**Architectural Installation Design Competition for
The 2025 National Games in Hong Kong**

Answers to Enquiries

Date of issue: 14 April 2025

(Drawing A24a)

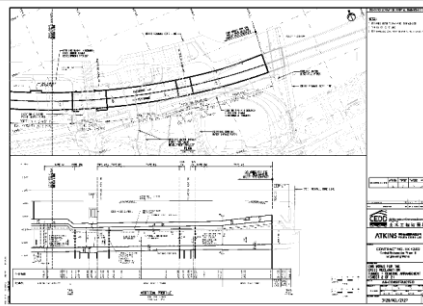
Please provide the cross section of the bypass (tunnel) below the site A.

The brief states '...No part of the footing shall encroach into 5m clear zone above the structure of the tunnel...' however, the position of the top slab of the tunnel in the attached long section for Site A is either missing or unclear. Please provide the elevation data of the slab relative to the ground level.

Please also provide the existing soil depth and top soil level.

The following drawings furnished by the Highways Department are attached herewith for your information. The topsoil level is approximate +5.5mpD to +6.0mpD. For the detail levels, please refer to the as-built site plan.
